U.S. Department
of Transportation
**Federal Highway
Administration**

In Reply Refer To:
HSSD/B-192

Name of system: BWW Enterprises Diamond Block
Type of system: W-Beam Guardrail Offset Block, 8-inch
Test Level: NCHRP Report 350 TL-3
Testing conducted by: Midwest Roadside Safety Facility
Date of request: March 4, 2009

Figure 7. Plastic Spacer Block Details, Test EXUL-1

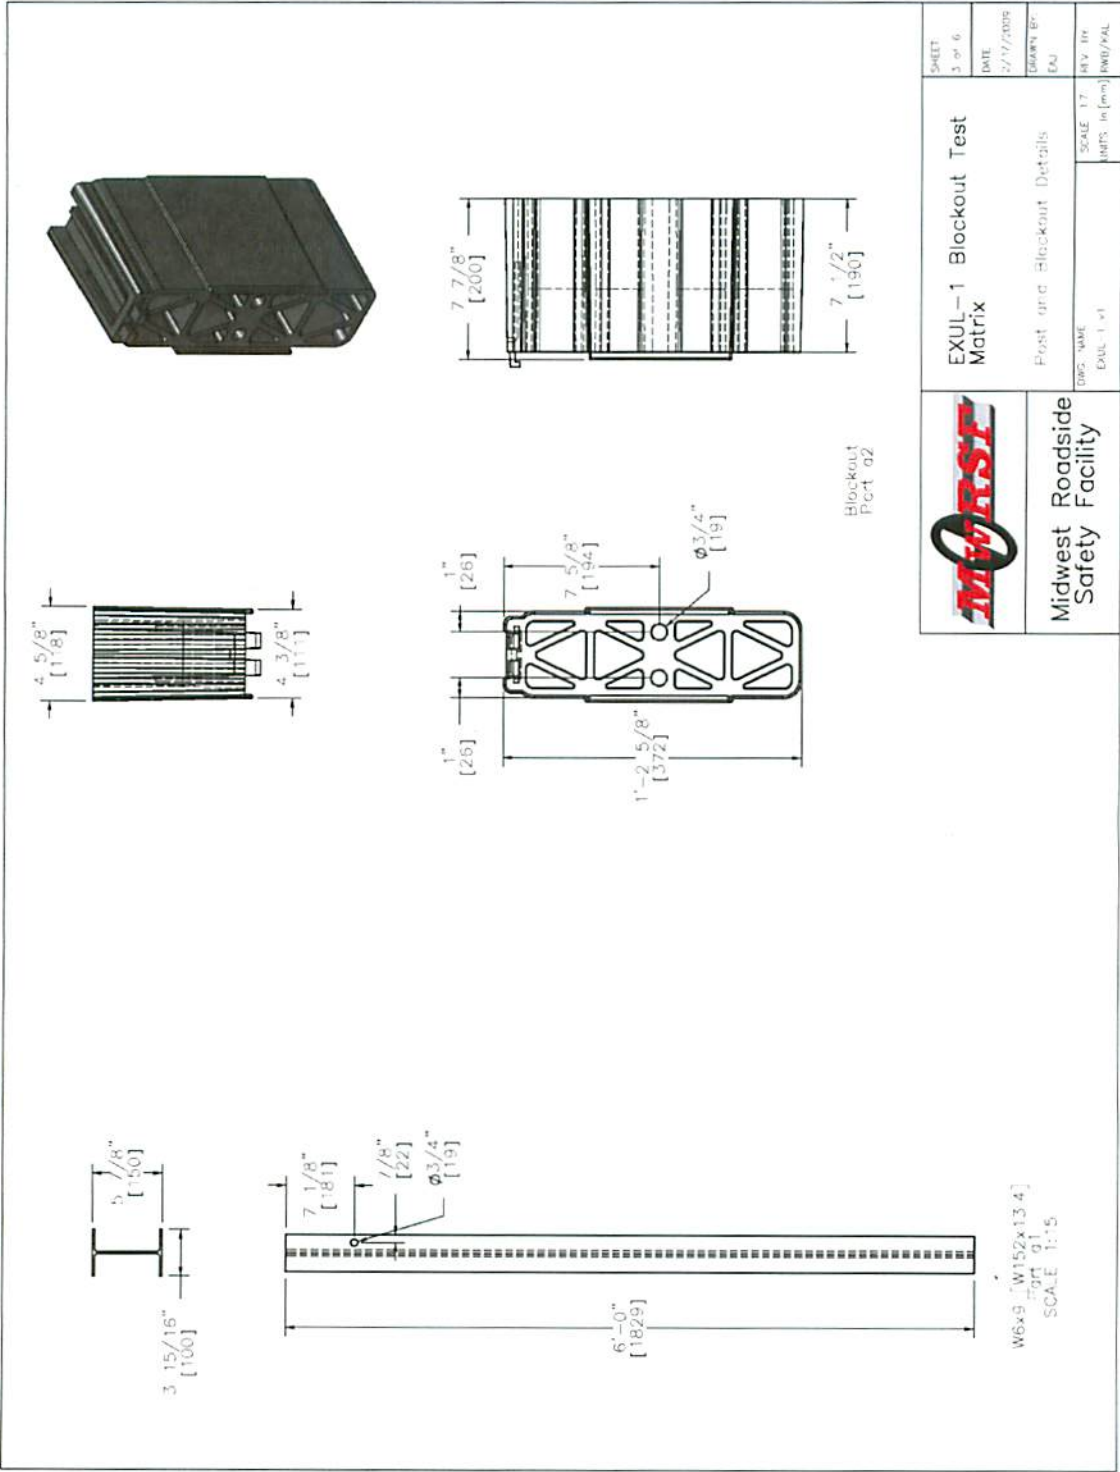
The Diamond Block is comprised of approximately 97.65 percent recycled high density polyethylene plastic, 1.25 percent chemical blowing agent, 1 percent carbon black, and 0.1 percent UV stabilizer. It measures approximately 7.5 inches x 4.6 inches x 14.5 inches tall with a recess on the back to accommodate the face of the guardrail post. The voided design of the block is seen in the drawing which is enclosed for reference. The block's weight is in the range of 5.8 to 5.9 pounds.

Therefore, the guardrail offset block described above and detailed in the enclosed drawing is acceptable for use on the NHS under the range of conditions tested, when such use is acceptable to a highway agency.
